MY2 Monitoring Report

Owen Farms Mitigation Site
Transylvania County, NC

Re: MY2 Monitoring Report Comments
Owen Farms Stream and Wetland Mitigation Site
French Broad River Basin; CU# 06010105 – Transylvania County
DMS Project ID No. 100064
Contract No. 7532
SAW-2018-01165

Response to DMS Comments

CURRENT CONDITIONS PLAN VIEW
OWEN FARMS MITIGATION SITE
 FIGURE 2.1

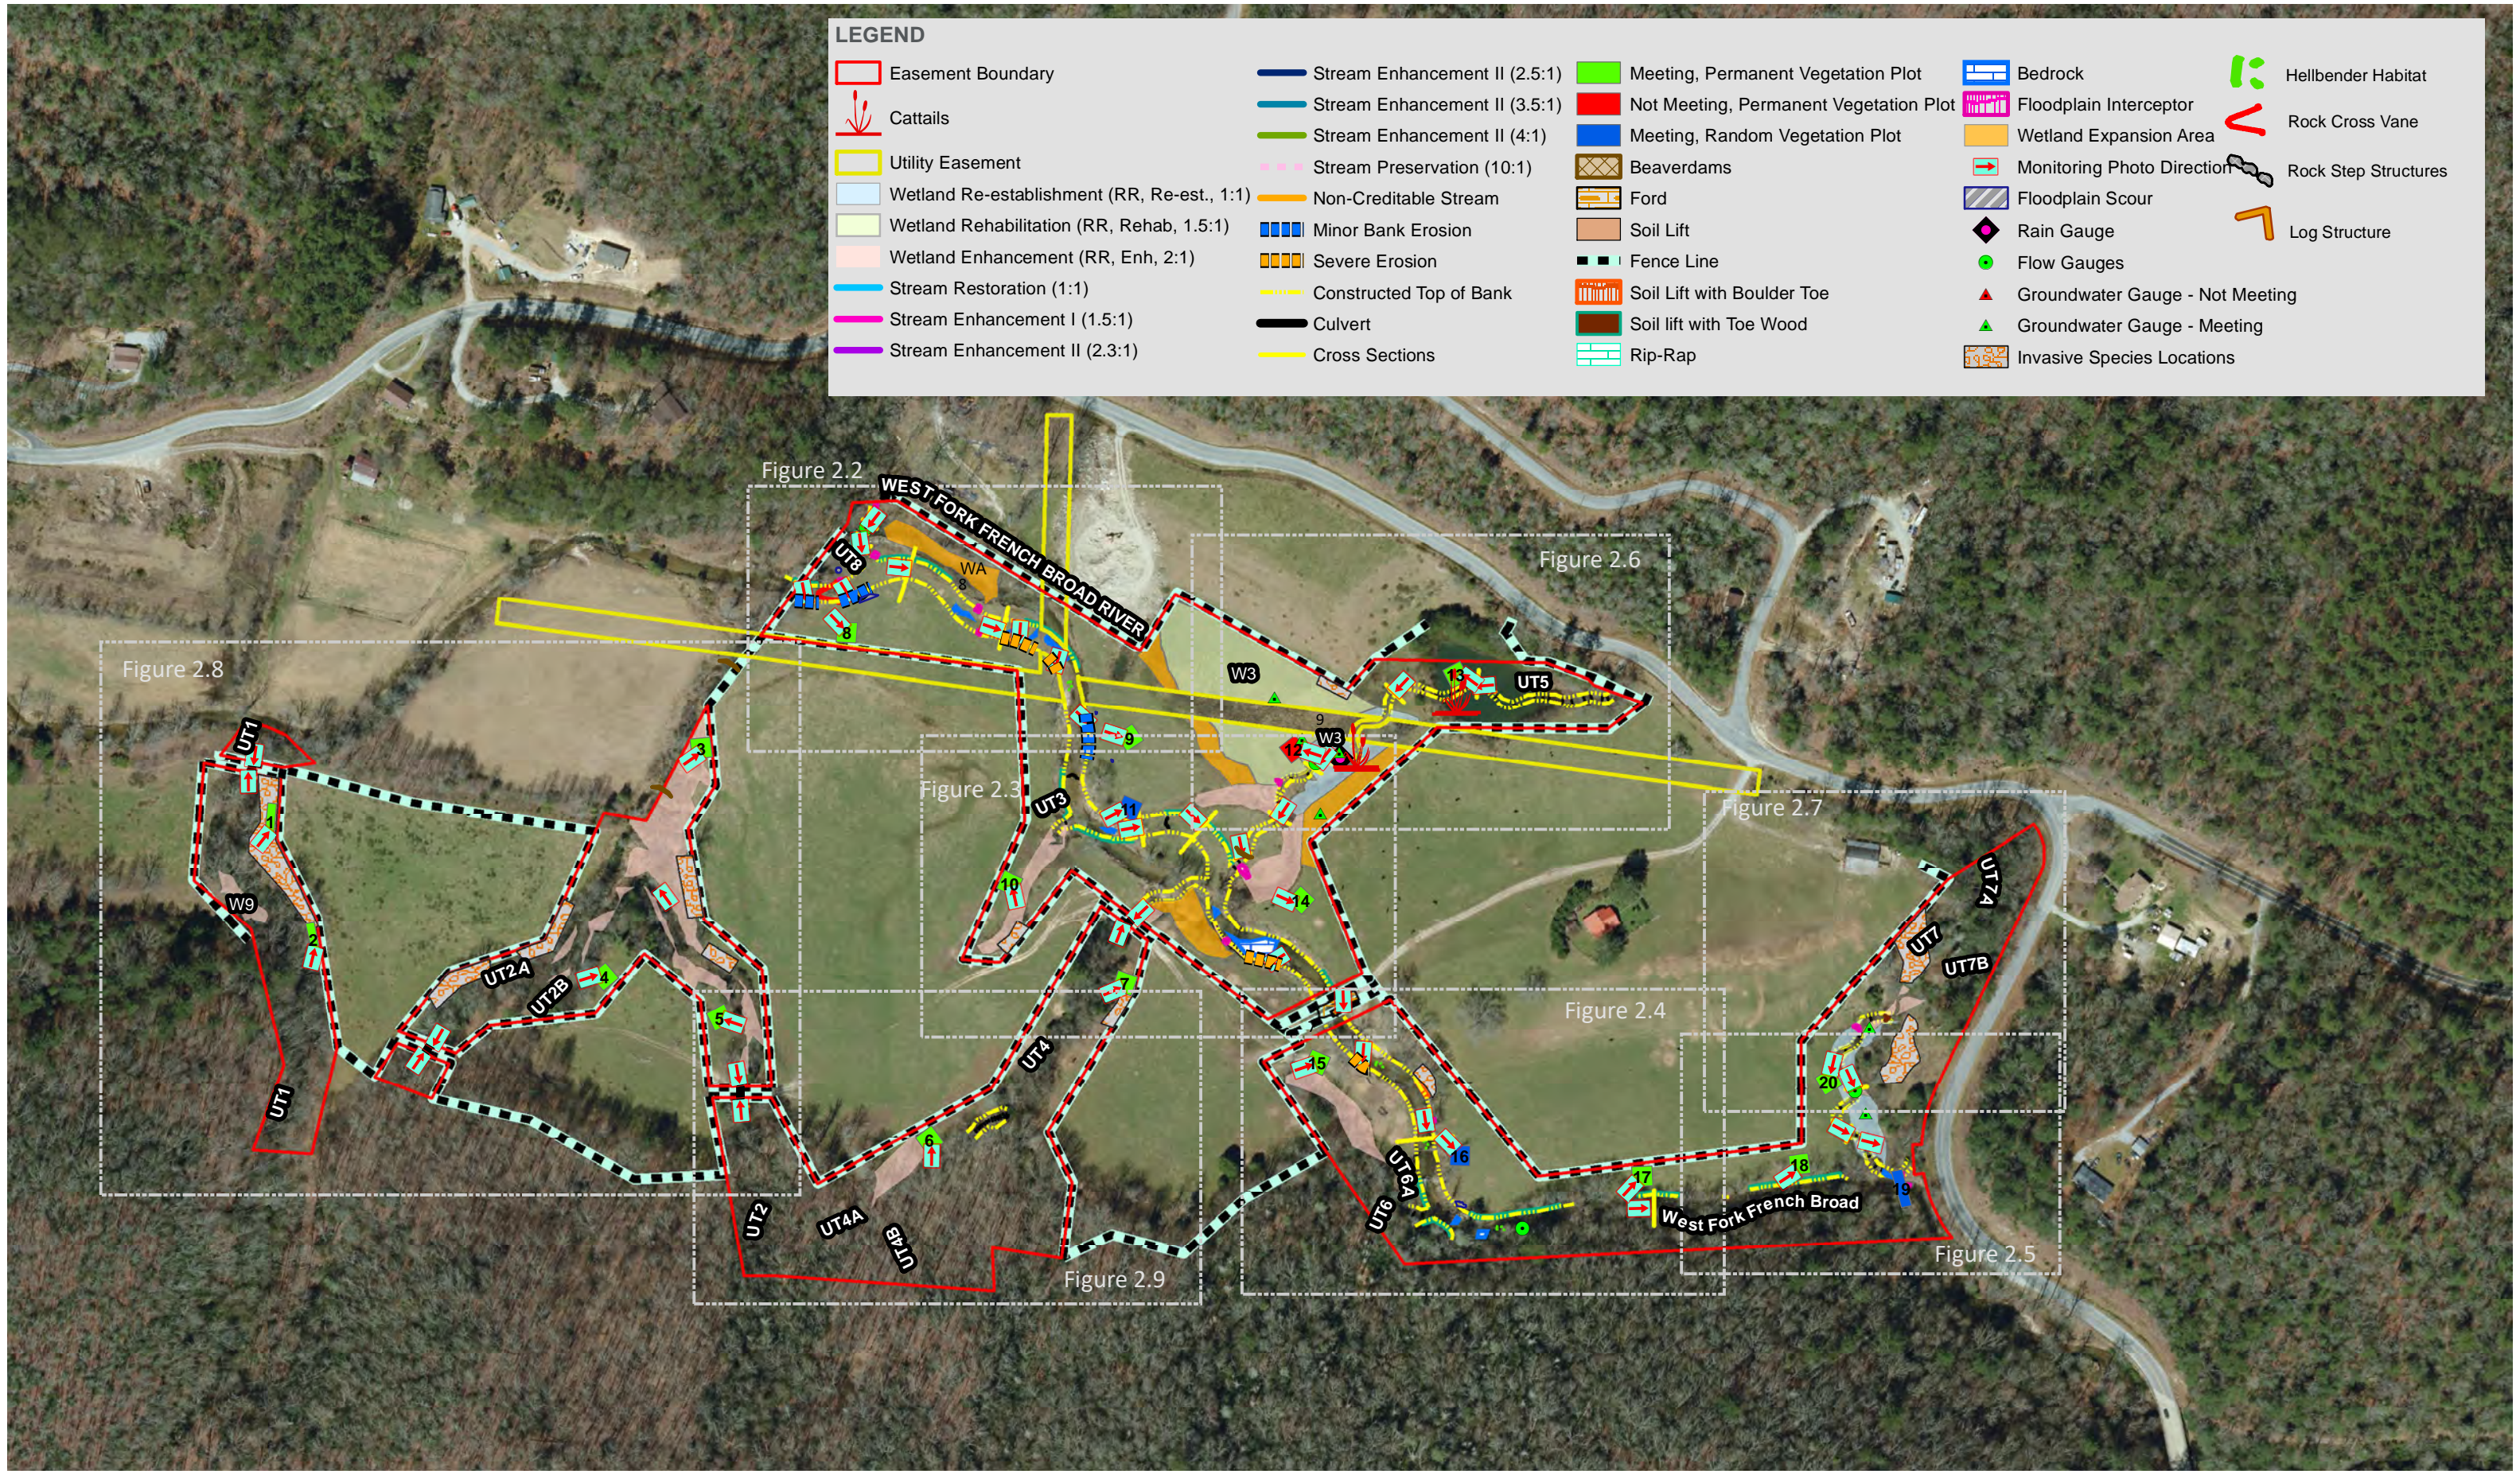
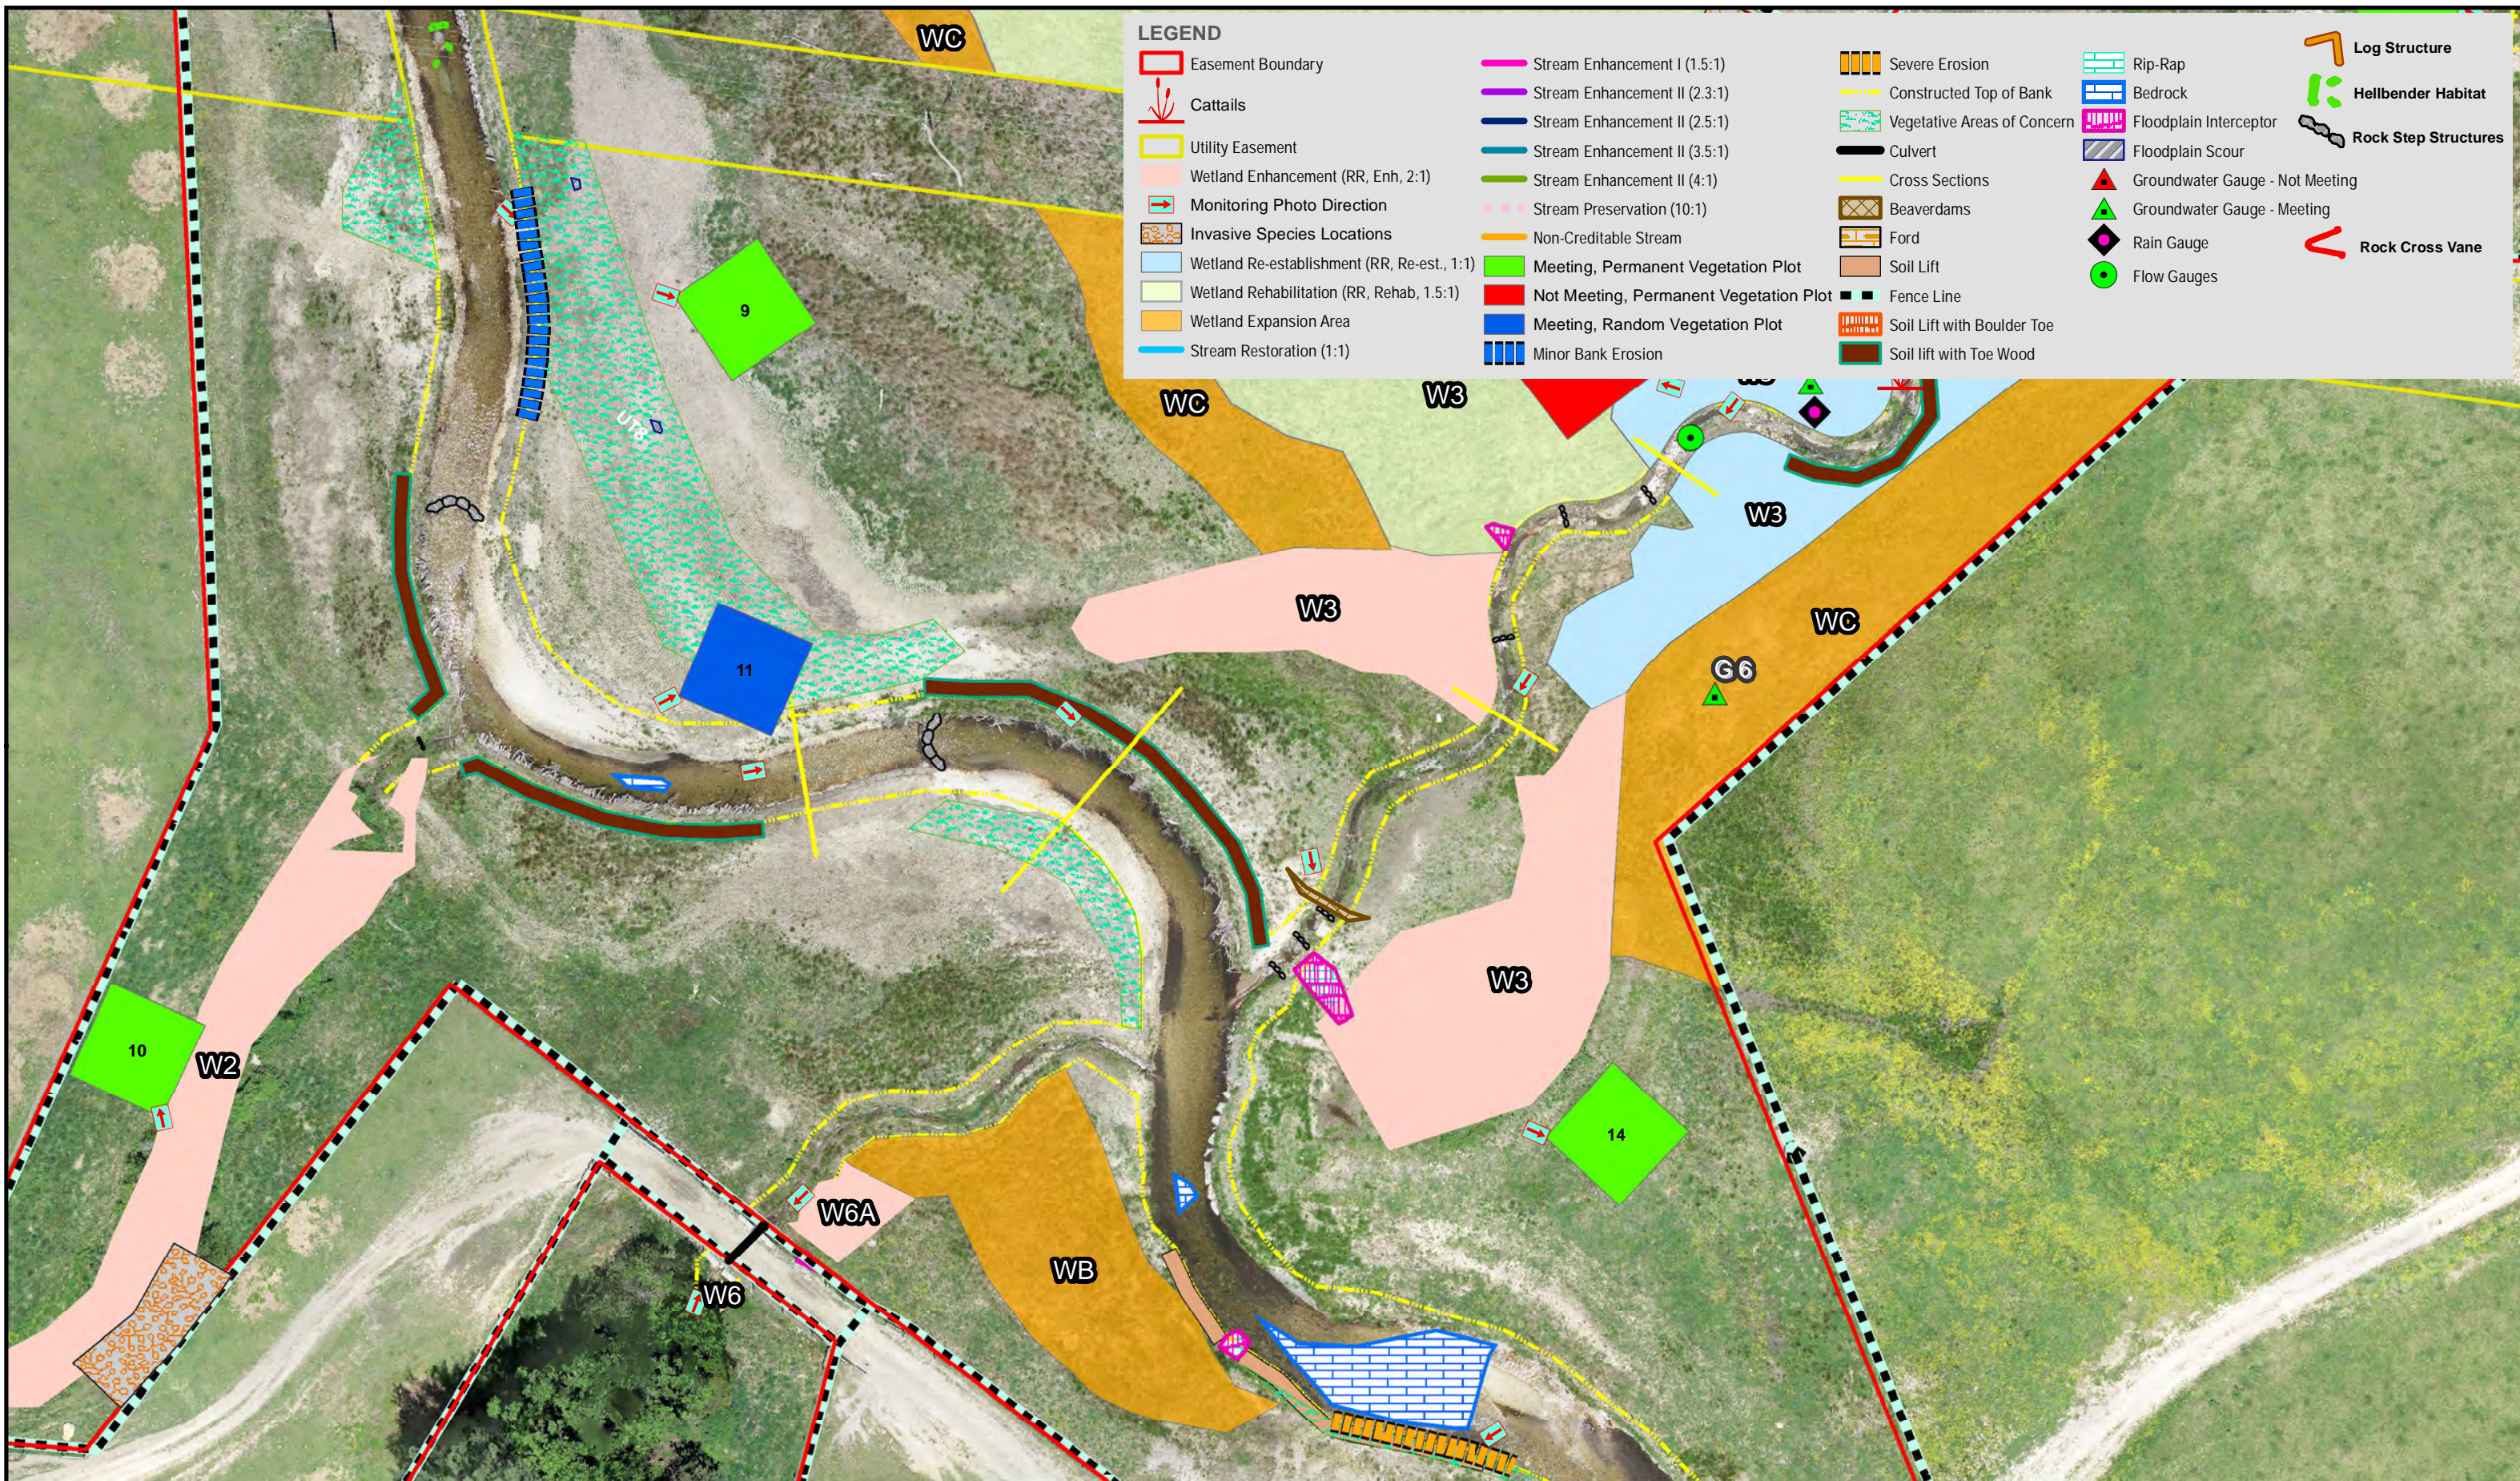
14: CCPV Maps: Please label the potential wetland expansion areas as identified in Appendix H – Wetland Expansion Area Letter to USACE. The CCPV has been updated to reflect labels on wetland expansion areas.

15: CCPV Maps: The random vegetation plots (11, 16, 19) should be identified as random plots on the CCPV Maps and legend. Were any the project's random plots located in MY1 replant areas as discussed with the IRT? Please discuss in the response letter and update the report text accordingly. Vegetation Plot 11 was located within the replant area. The CCPV has been updated to reflect random, permanent, meeting and not meeting.
